Informazioni sul prodotto - Pastiglie freni | HELLA

Pastiglie freni

8DB 355 011-401 / 8DB 355 015-961

Pastiglie freni modificate

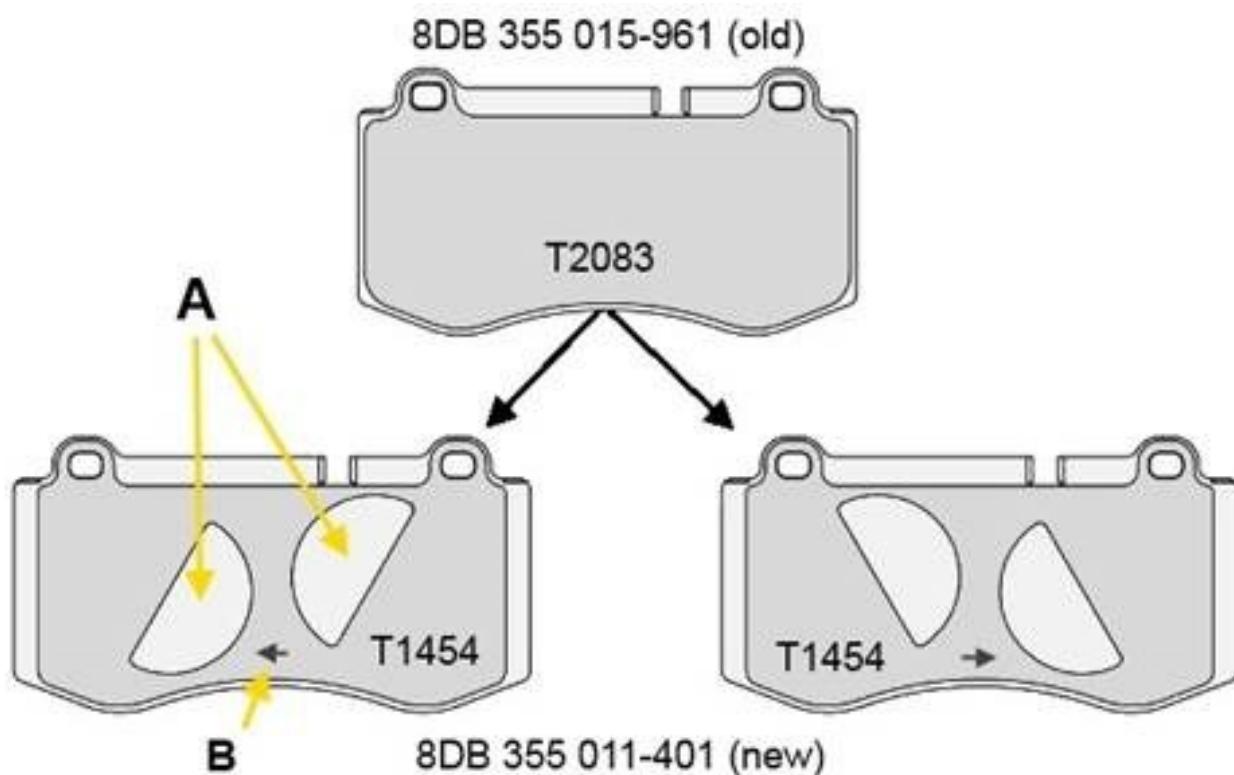
La pastiglia 8DB 355 015-961 / T2083 è sostituita dalla pastiglia 8DB 355 011-401 / T1454.

La differenza tra le due guarnizioni dei freni è una modifica nella piastra di smorzamento sulla piastra posteriore della guarnizione del freno. Tale modifica migliora la sensibilità al rumore e quindi le proprietà di comfort della pastiglia.

Per le nuove piastre di smorzamento, con recesso (A), è necessaria un'installazione correlata con la direzione di marcia. L'orientamento del montaggio è indicato da una freccia (B).
